Waitakere City Council Feedback and Comments on: NRC Concept Design Report For NAL Stage 2 Duplication (New Lynn to Henderson) October 2004.

Proposed Rail Corridor Cycleway – New Lynn to Henderson

Waitakere Central – Henderson Interchange
Developed Design Sign Off

To	Kevin Wright
From	Warren Cornor
Date	23 December 2004
Subject	Henderson Interchange

FRUITVALE STATION PLAN
SCALE – 1:1000

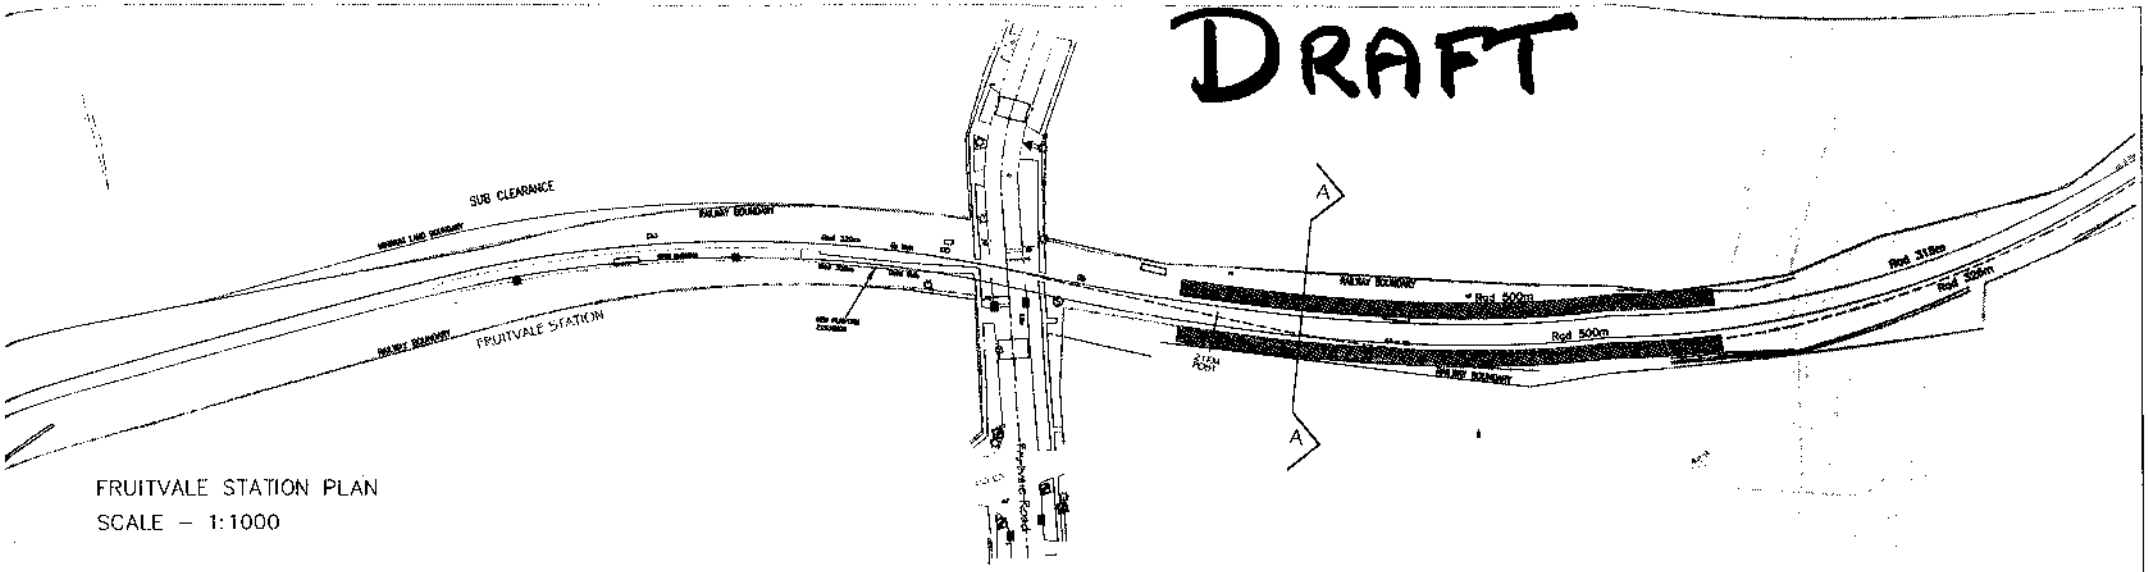
- This section doesn't address pedestrian handling as part of level crossings. This is particularly important at Fruitvale where the crossing is close to a school, and frequently used by its pupils. There is a crossing identified north of Henderson, the Mt Lebanon crossing, that needs to be considered in the report.

- Drawing 4 - 21, Fruitvale Station/Mason Park: there appears to be some encroachment into the reserve. This could be a complicated matter. Waitakere had some consultation on this in the past (with respect to the station relocation etc) and the community were opposed to some of the concepts.
- Further to this there are also some complicated land ownerships of Mason Park as well - some Council, some DoC owned, some held for rail purposes (which may make the encroachment easier). This will need to be clarified.

N.A.L. DUPLICATION
GLEN EDEN STATION
CROSS-SECTION

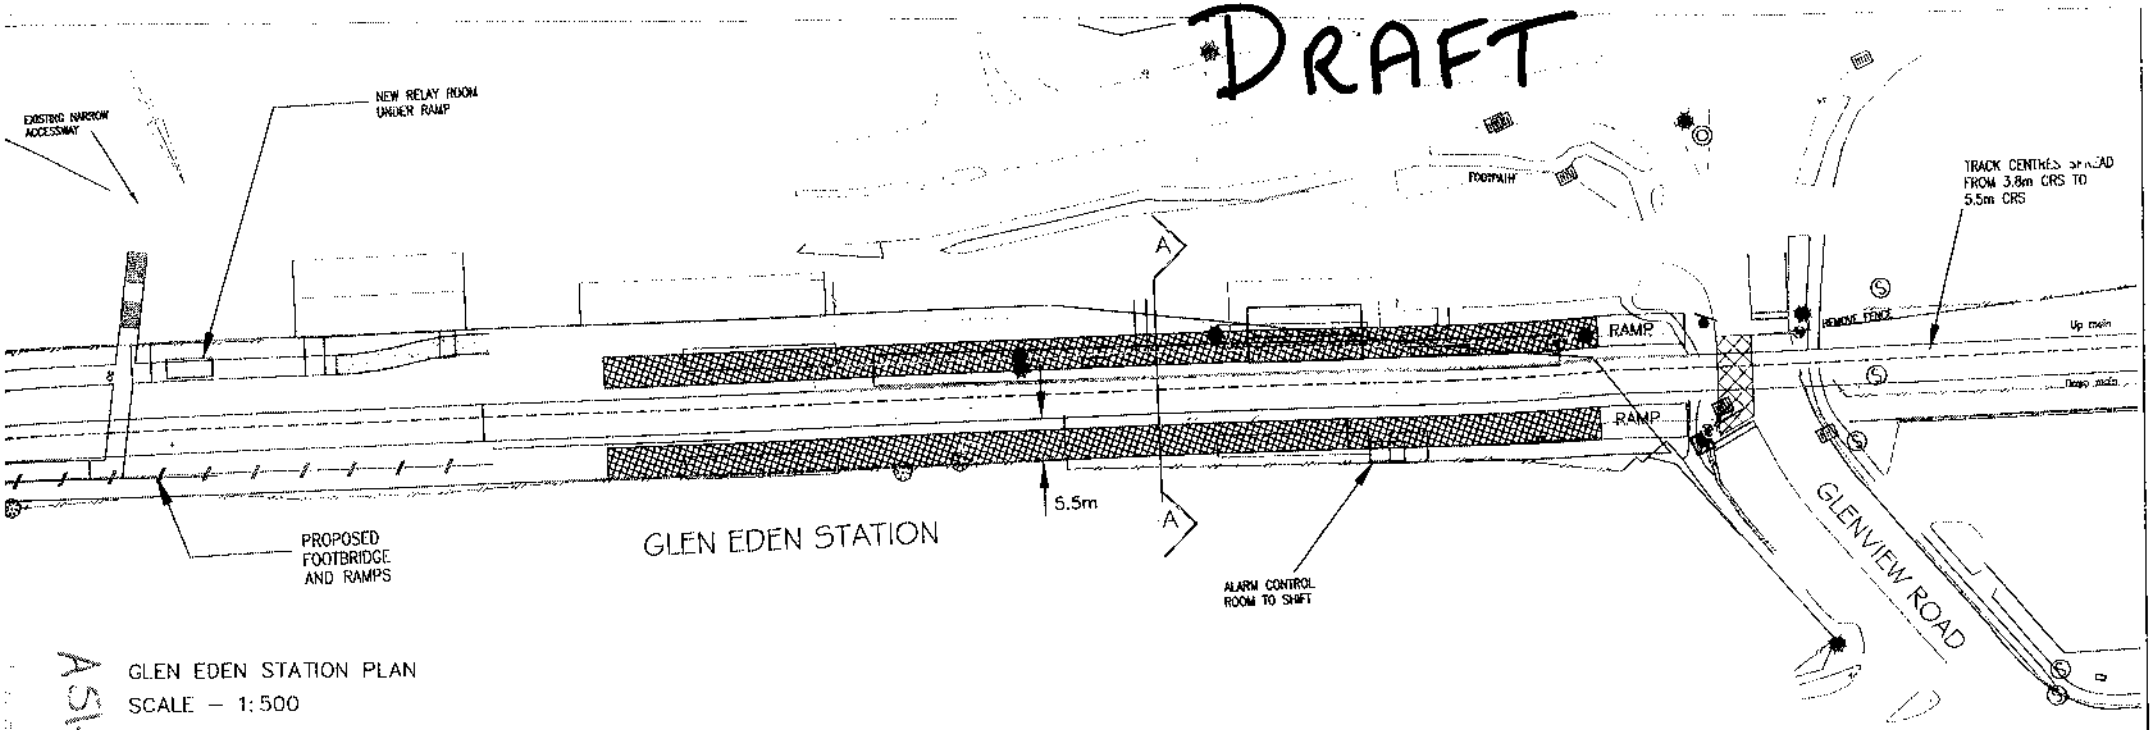
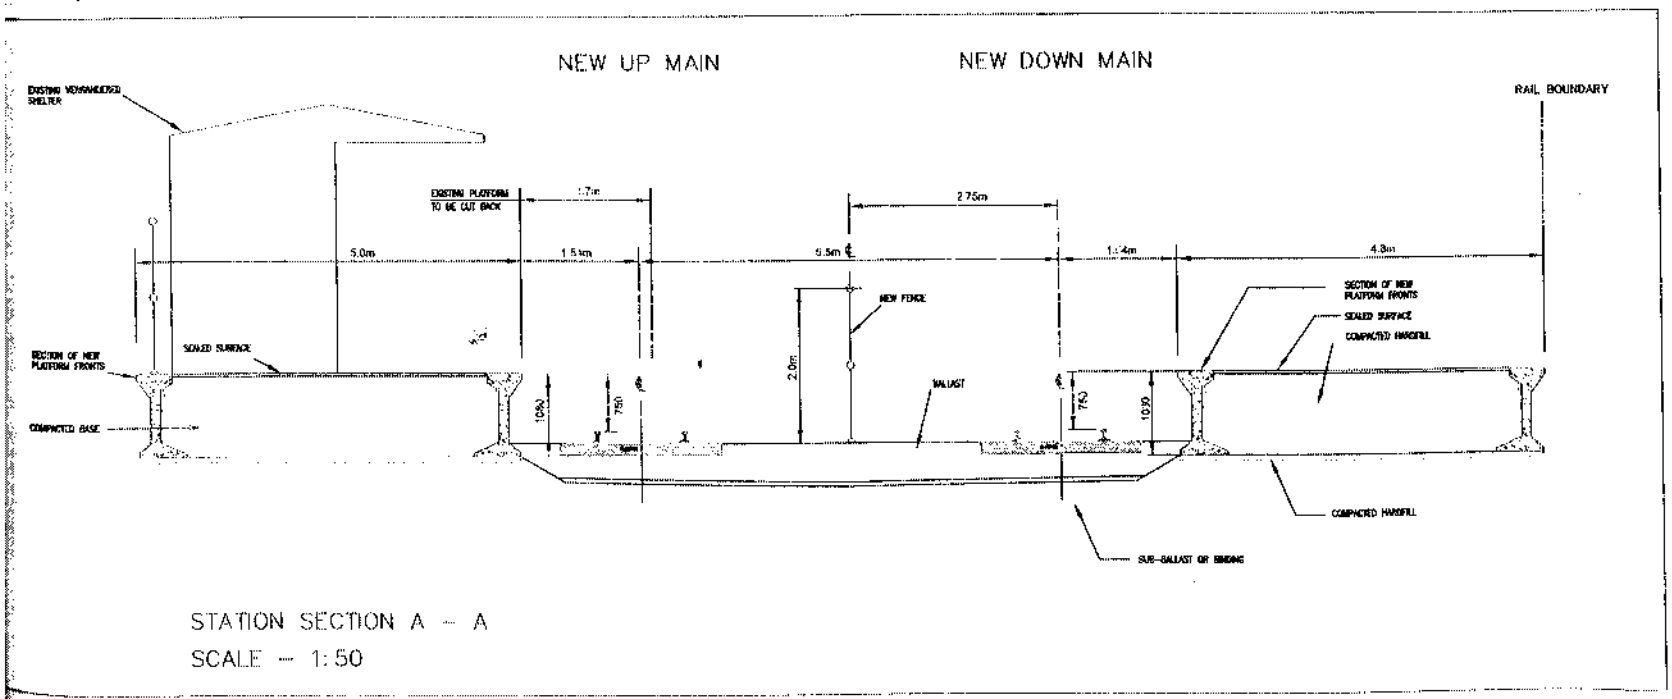
- Glen Eden
  - The proposal to cut 1.7 m from the Glen Eden platform will require the station canopy to be cut back and will result in a platform width (in front of the heritage building) below the ARC minimum standard. WCC requests to work with the ARC and other rail parties in considering options for Glen Eden, including removal of the centre fencing, moving of the building, acceptance of the width, and other options. This is an area where there is likely to be strong political interest.
  - There is a need to develop a regionally agreed policy on the design of shelters adjacent heritage stations.

N.A.L. DUPLICATION
SUNNYVALE STATION
CROSS-SECTION

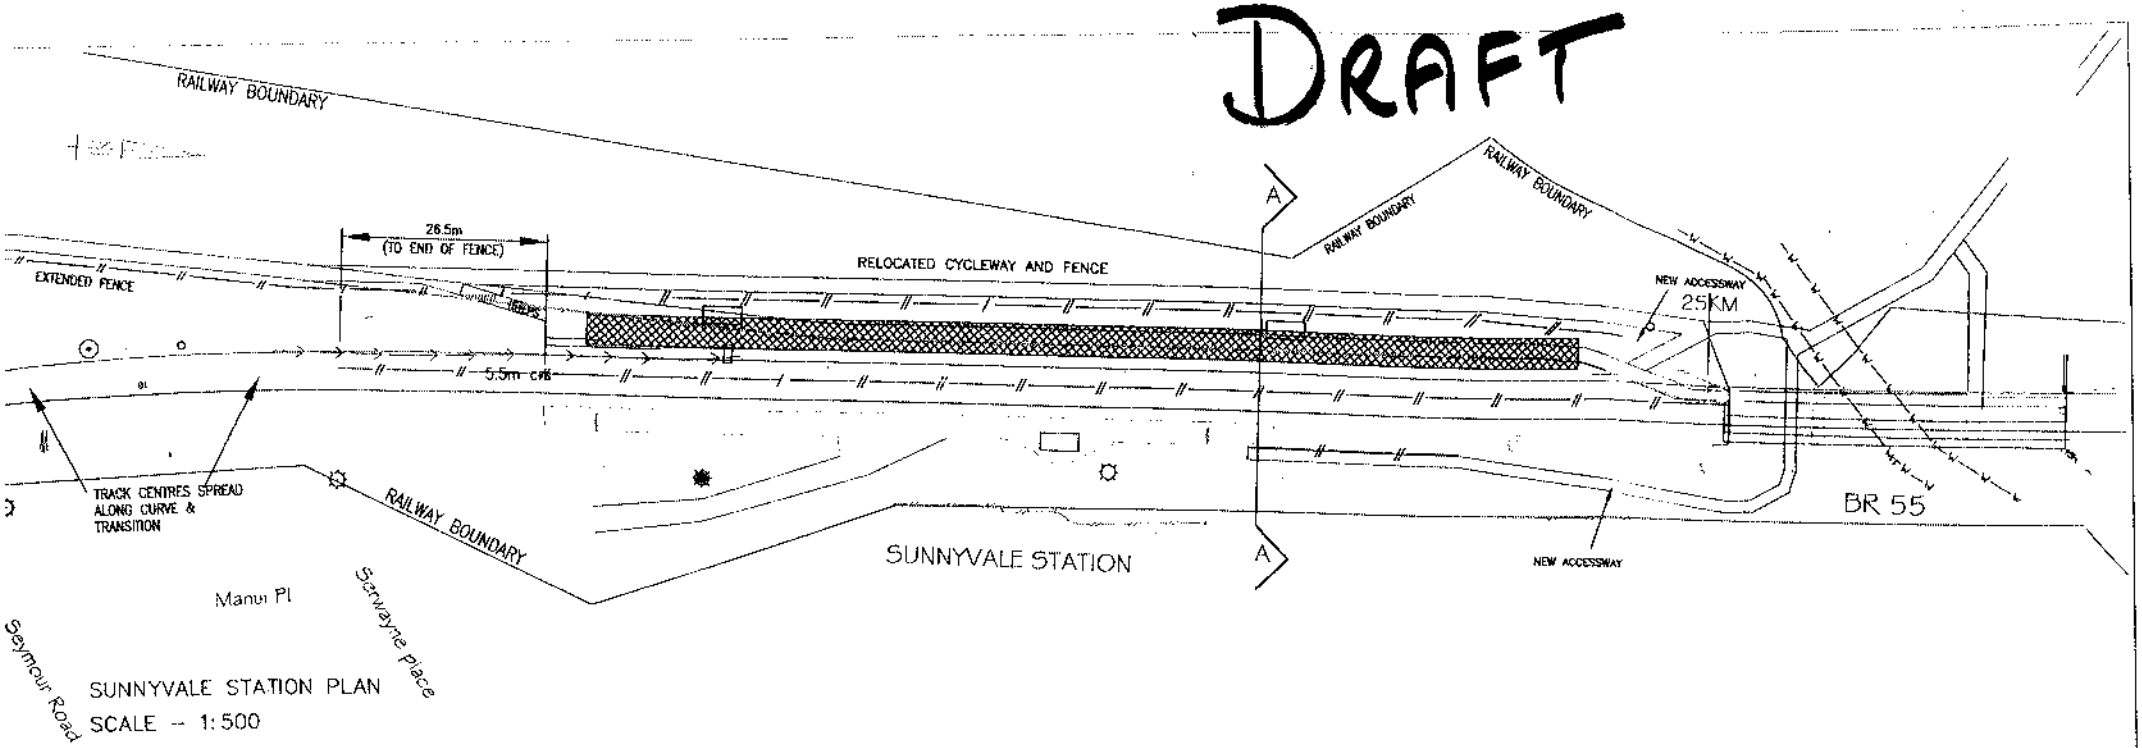
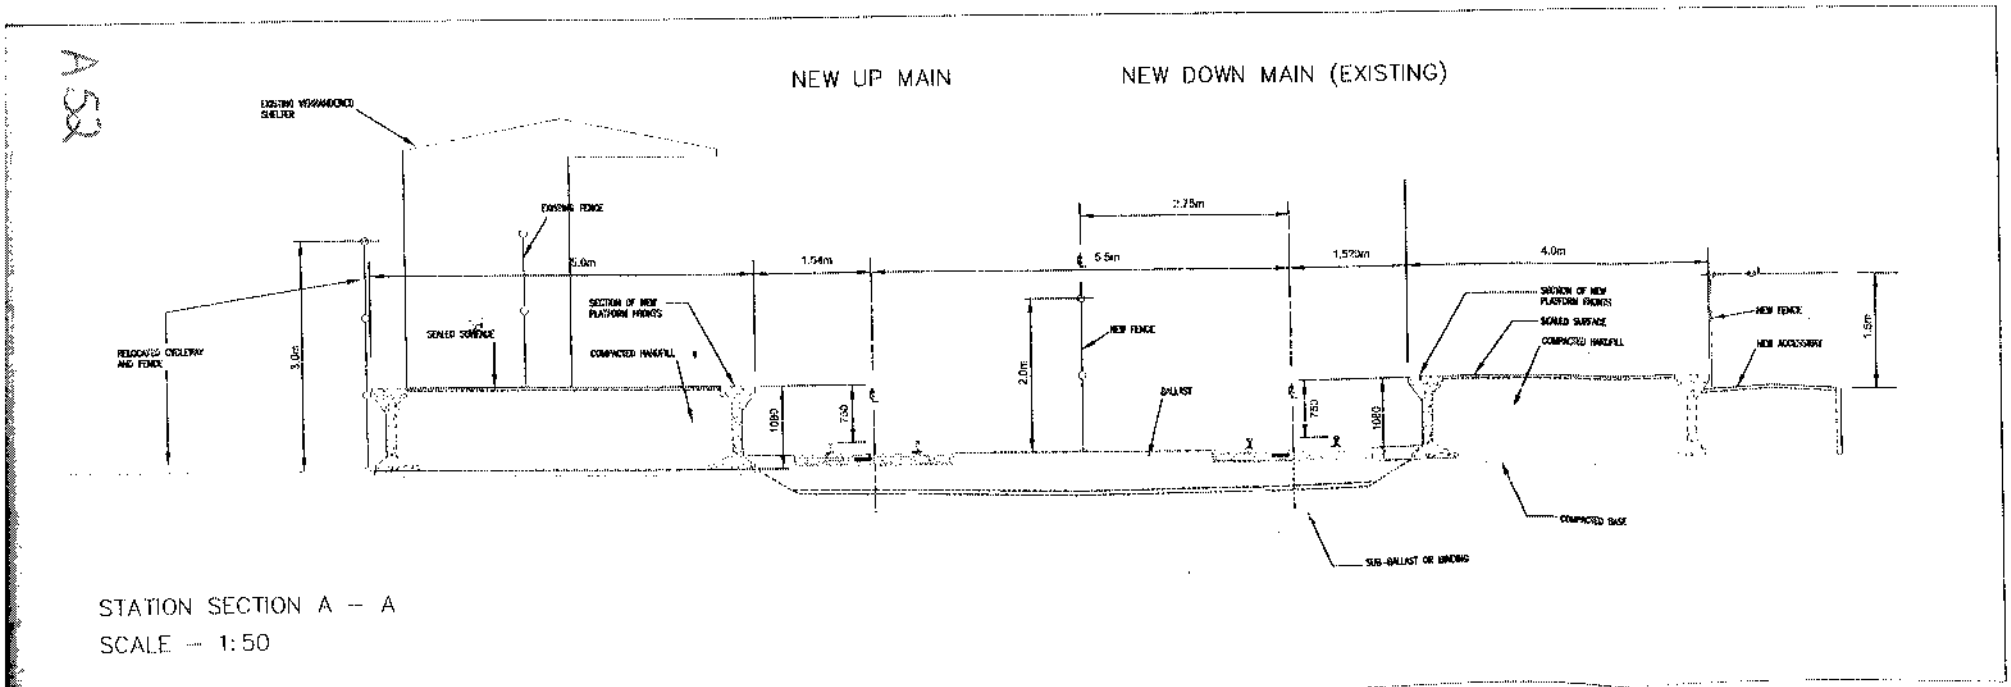
- To ensure that no rail options for New Lynn, including undergrounding, are foreclosed prior to Stage 3 concept design work.
    -
- At Sunnyvale station the proposed cycle track loops under the road bridge and back to the opposite side of the road to cross the bridge, this is not desirable. There are a couple of options open that WCC are currently investigating:

N.A.L. DUPLICATION
HENDERSON STATION
CROSS-SECTION

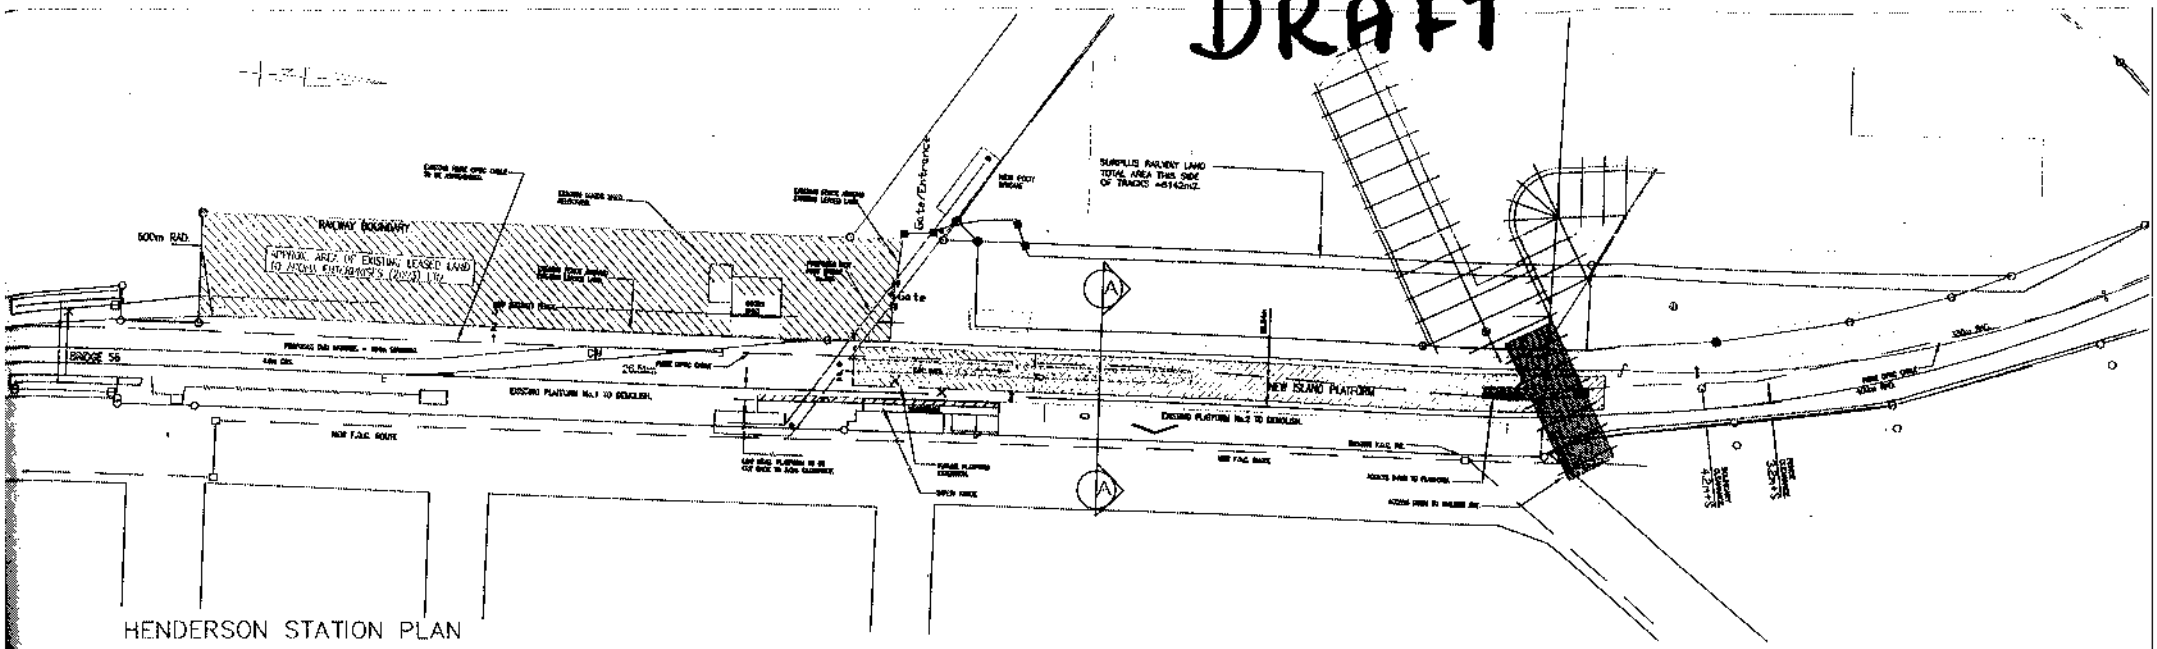
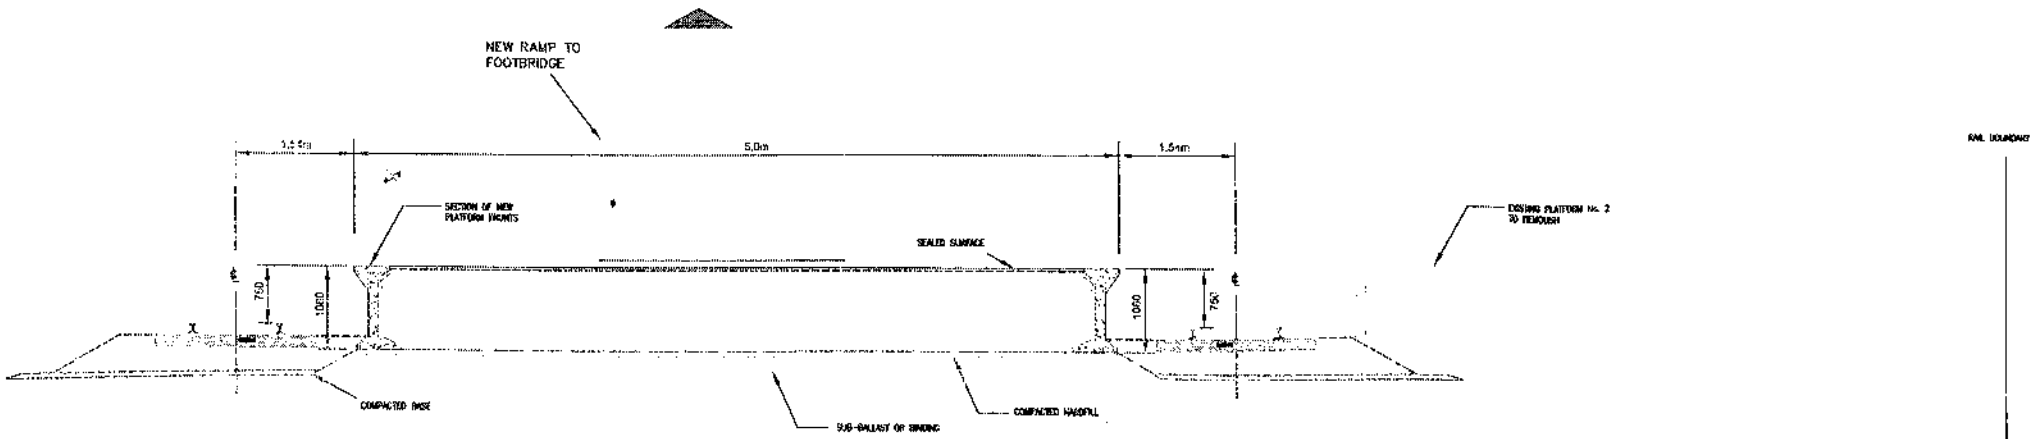
- Shows Henderson as side platforms

- Henderson
  - Lifts – These are required from a PT perspective to provide disabled access to the station and should therefore be funded as part of the double tracking project.
